COUNCIL ASSESSMENT BRIEFING REPORT TO PANEL

SYDNEY SOUTH PLANNING PANEL

PANEL REFERENCE & DA NUMBER	PPSSSH-143 – DA2023/0222 – PAN-333974
PROPOSAL	Demolition of existing structures, construction of a 10 storey mixed use development, comprising 112 residential apartments, 3 commercial tenancies, four levels of basement car parking providing 143 car parking spaces, landscaping and site works.
ADDRESS	1-5 Stanley Street and 1–11 Princes Highway, Kogarah
APPLICANT	Aaron Sutherland – Sutherland & Associates Planning
OWNER	Kogarah Investments No.3 Pty Ltd
DA LODGEMENT DATE	12 July 2023
APPLICATION TYPE	Development Application (Integrated)
REGIONALLY SIGNIFICANT CRITERIA	Section 2.19(1) and Clause 2 of Schedule 6 of <i>State Environmental Planning Policy (Planning Systems) 2021</i> declares the proposal regionally significant development as: The development has a capital investment value of more than \$30 million.
CIV	\$34,864,225.00 (excluding GST)
CLAUSE 4.6 REQUESTS	Nil and zoning R4 High Density Residential

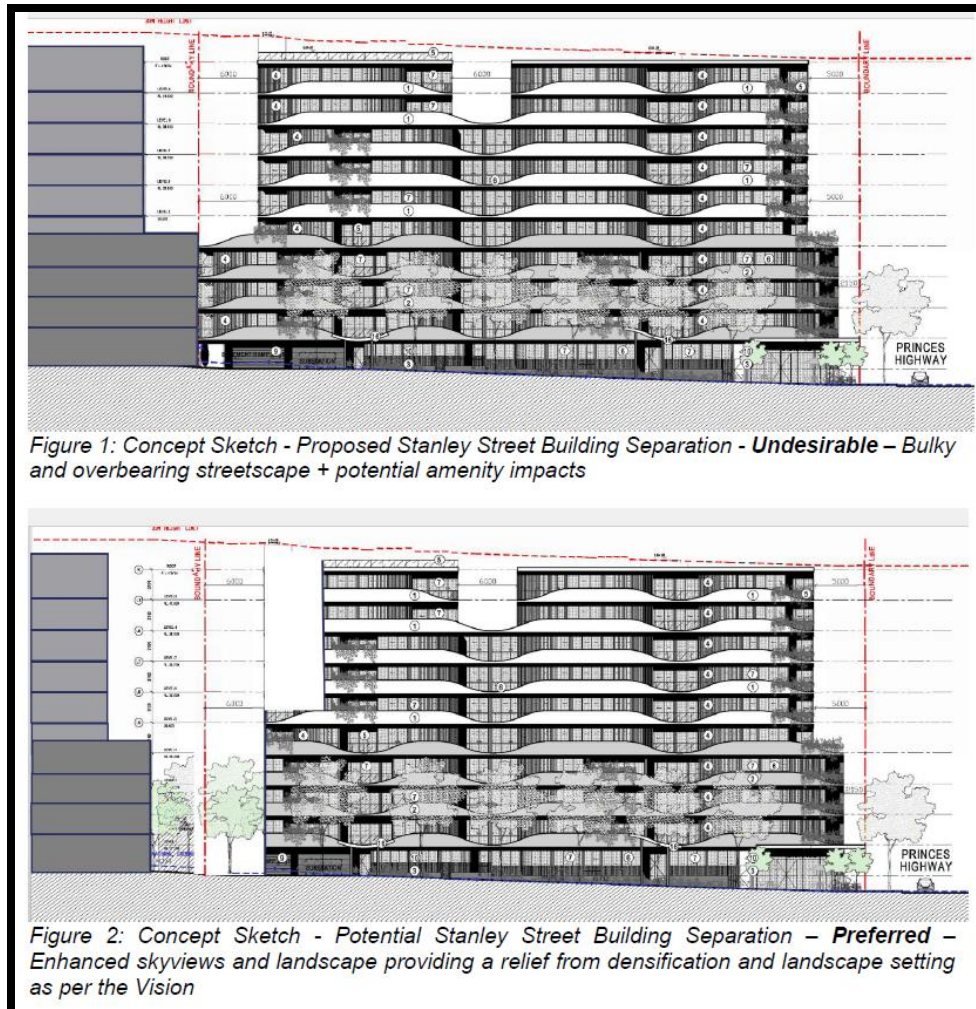
While, the ADG has established that building separation not only ensures that amenity between buildings is maintained but also contributes to the urban form of an area. Hence, one of the aims of building separation under Part 2F of the ADG is to:

- *ensure that new development is scaled to support the desired future character with appropriate massing and spaces between buildings*

It should be noted that the subject site lies within the R4 – High Density Residential area and a continuous podium is not desired. Continuous podium is only appropriate in the business/commercial zones. The lack of setback to the west denies the opportunity for deep soil planting and landscaping to realise the vision. The proposal and any future development to the west will result in overbearing streetscape devoid of landscaping to minimise the impact of building bulk (Refer Figures 1 and 2).
